NACELLE - POWER PLANT - OIL FILLER ACCESS DOOR - OIL TANK OVERSERVICING DECAL -INSTALLATION OF - CATEGORY CODE 4 - MOD.NAC-71-0037

# SERVICE BULLETIN

Installation of an Oil Tank Overservicing Decal to the Oil Filler Access Door Fig.1

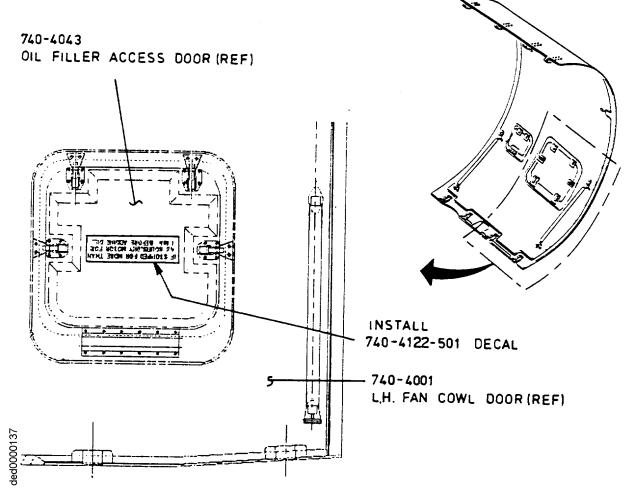
An oil tank overservicing decal (self-adhesive type) is installed upside down on the oil filler access door.

- (2) Clean the internal surface where the decal will be installed on the oil filler access door with trichloroethylene. Allow the door to dry.
- (3) Cut the 740-4122-501 decal to the assembly trim line. Remove the backing from the decal. Install it on the oil filler access door in the approximate position shown in Figure 1.

NOTE: The decal is designed to be read when the door is fully open.
